Our Reference: 80058-CUR-XX-XX-T-TP-00006-P01

Re: Alberton House (134287/FO/2022)

This letter has been prepared to address the post-submission response received from Manchester City Council (MCC) Highways on 3rd August 2022, Ref: 13382/FO/2022. The response sets out the comment received in *italics* and Curtins' response below.

Post Submission Note

Drawing 80058-CUR-XX-00-D-TP-75002 – Proposed Loading Bay (Option 1)

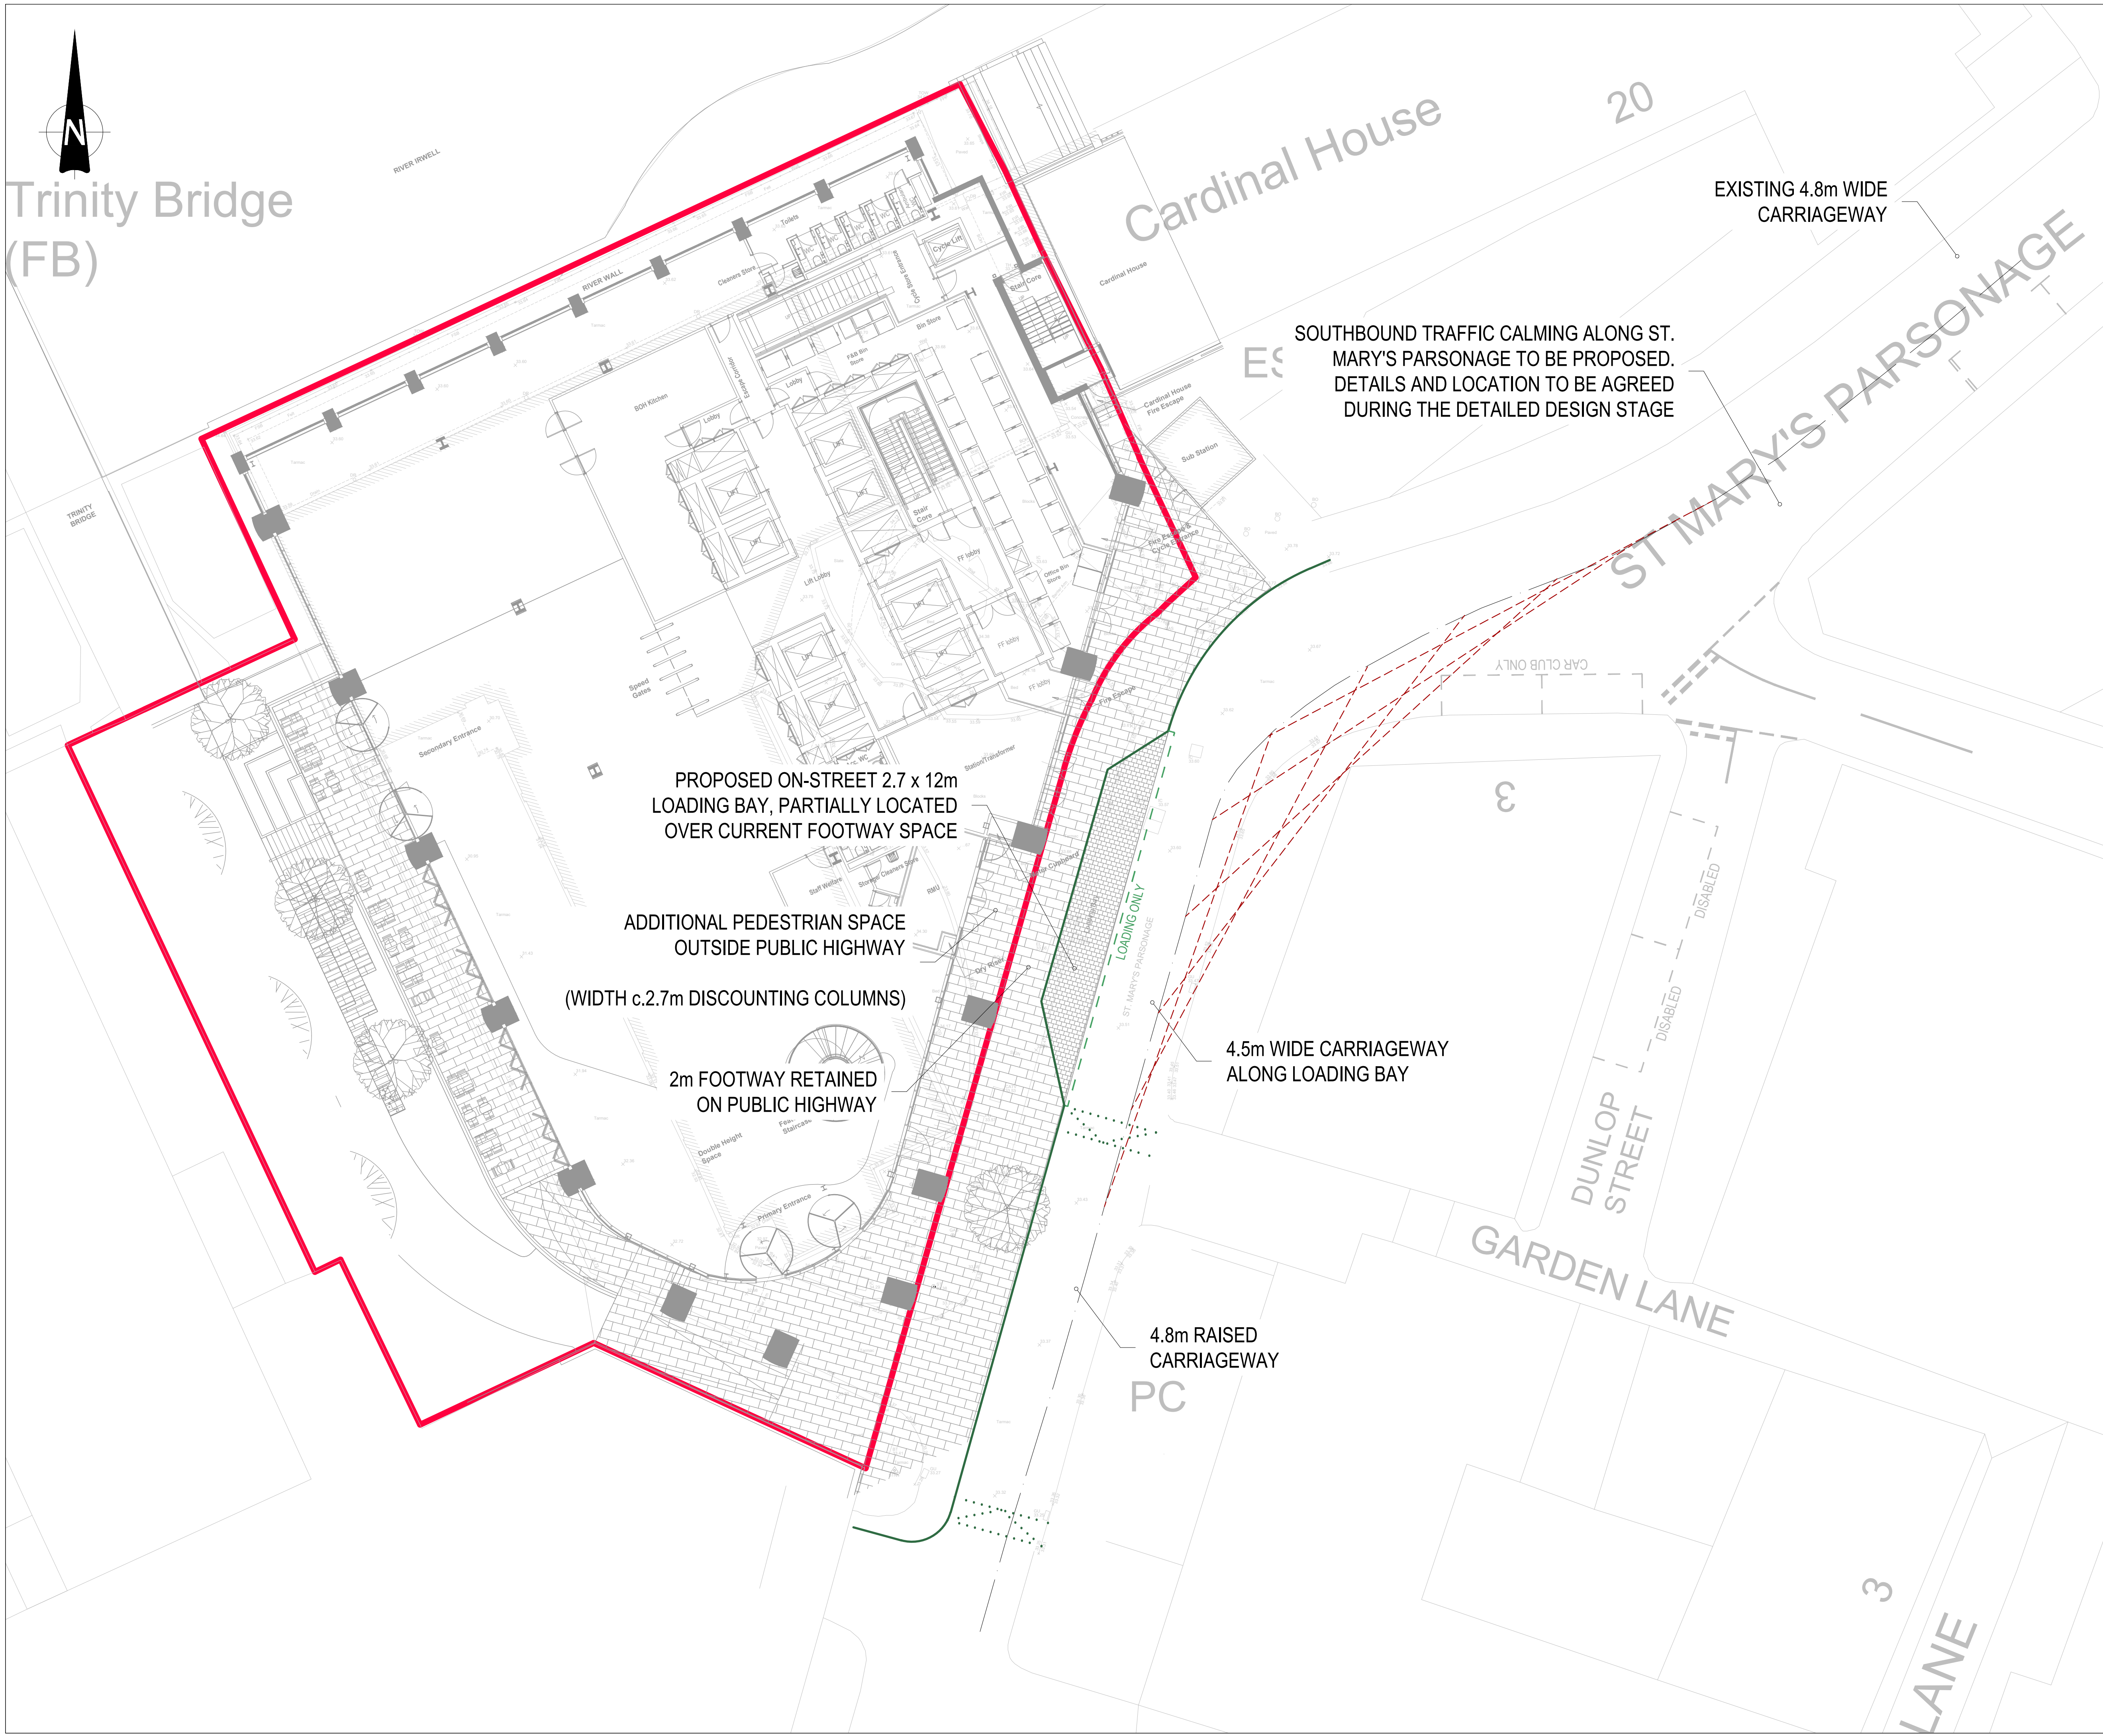
The RSA detailed concerns for the of the lack of measures proposed on St. Marys Parsonage southbound. Given that Highways has similar concerns it was requested that the developer provides some form of speed reduction measures to mitigate the provision of the new loading bay. This request applied to both of the scoping options.

Highways would accept either Option 1 or Option 2, but on the condition that traffic calming is proposed on St. Marys Parsonage southbound. It is recommended that the above is conditioned and attached to any planning permission that may be granted.

Curtins note the above and confirms that Bruntwood have no objections to introducing some form of traffic calming measures. It is Curtins' view that details of the traffic calming measures could be developed further at a detailed design stage and a condition would adequately secure this.

Notwithstanding, the proposed locations of the traffic calming measures have been added to the drawings of the 2 loading bay options, namely **Drawings 80058-CUR-XX-00-D-TP-75002** and **80058-CUR-XX-00-D-TP-75003** appended to the rear of the report.

SOUTHBOUND TRAFFIC CALMING ALONG ST.
MARY'S PARSONAGE TO BE PROPOSED.
DETAILS AND LOCATION TO BE AGREED
DURING THE DETAILED DESIGN STAGE
